CITY OF ALBUQUERQUE

RE: **Juan Tabo Hills Park**
Grading and Drainage Plan for SPBP – Approved
Engineer's Stamp Date: 9/12/2018 (M22D017A)

RE: JUAN TABO HILLS PARK (M22D017A)

JUAN TABO HILLS PARK - PHASE 1
OVERALL GRADING AND DRAINAGE CONCEPT

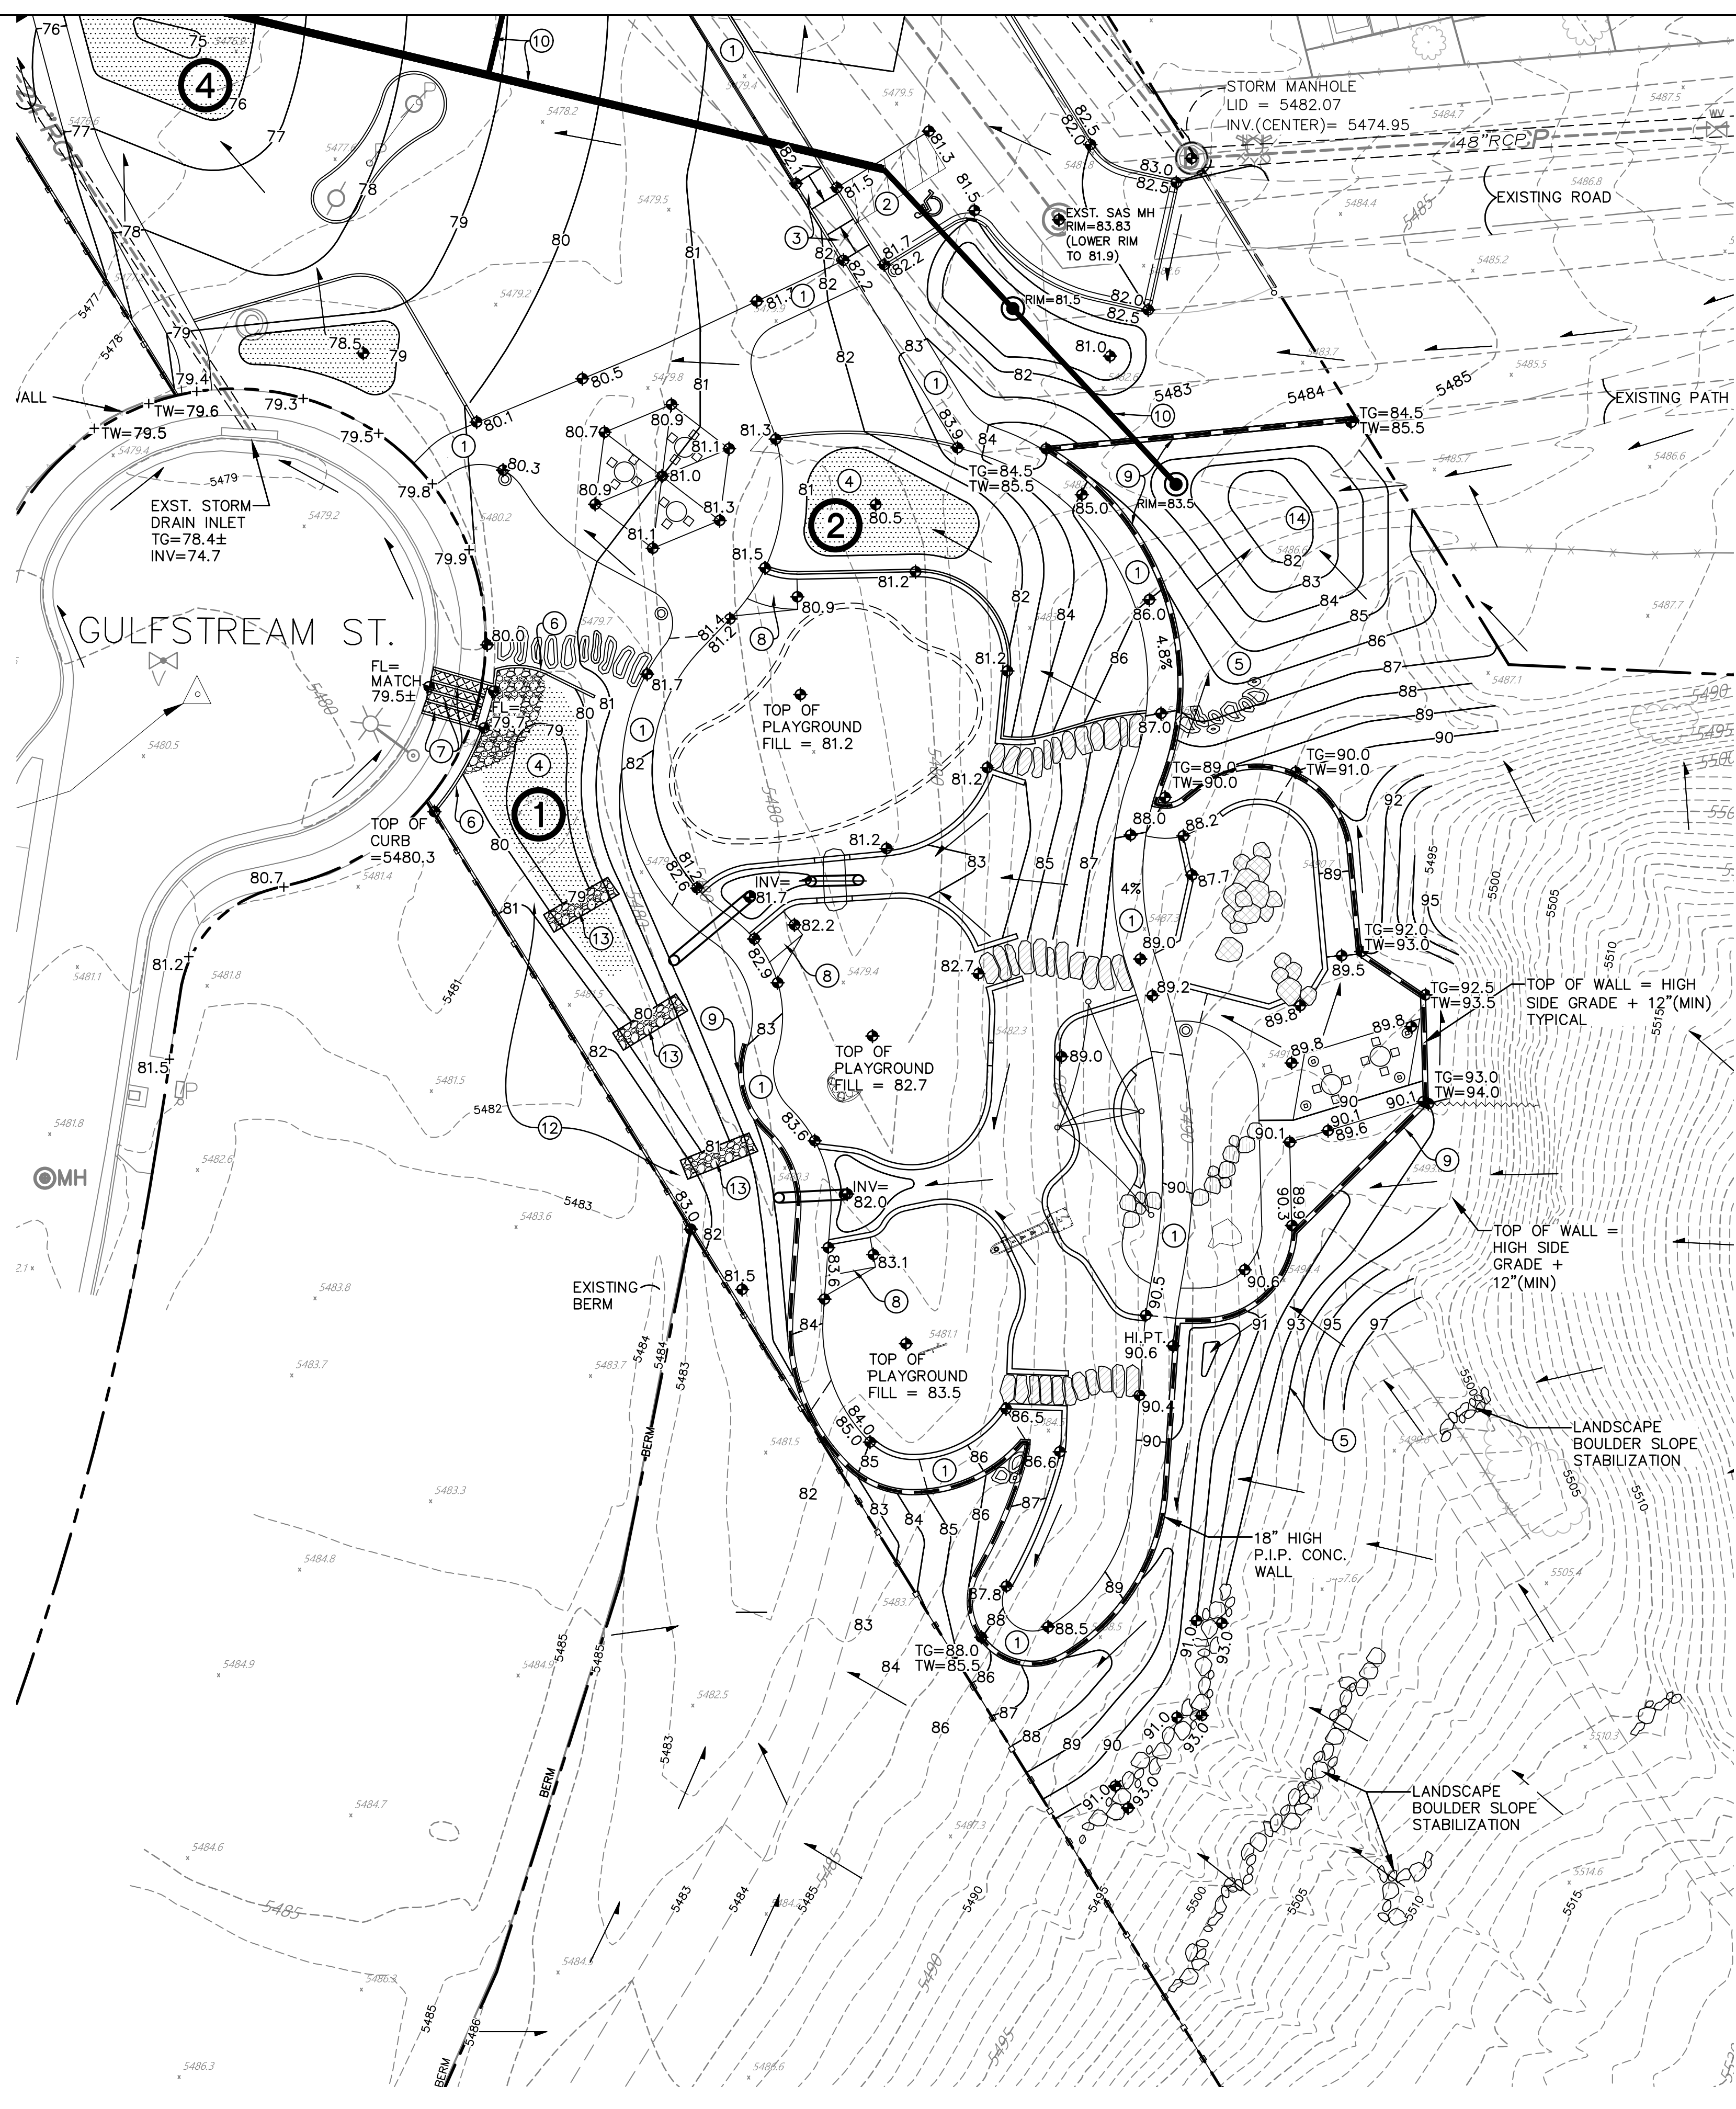
1. Remove the label "Not for Construction" under the engineer's stamp and sign the stamp.
2. Verify the Sidewalk Culver Capacity using the weir equation. Grates are now standardized at 24". Use the appropriate number of grates.
3. Add a construction note on the plan stating that an excavation and barricading permit is required for the New Type D inlet on the existing public storm drain and the Sidewalk Culverts.
4. Verify the Gulfstream Ct. inlet calculations using a weir equation at the lip of gutter, which is 0.75' below the property line elevation.
5. Grant Public Drainage easements on the existing 48"- 66" storm drain on the east side of the site (25' min width centered on the pipe) both north and south of Monachos Rd.

- Impervious area and first flush pond calculations. All impervious areas are directed to First Flush retention ponds with volumes exceeding required volume.
- Sidewalk culvert capacity calculations.
- Sump inlet capacity calculations.
- Storm drain calculations.
- No off-site grading is shown on this plan. The Parks Department understands that written permission from the owner of the lot to the southwest will be required if off-site grading is necessary.
- All calculations have been stamped and signed.
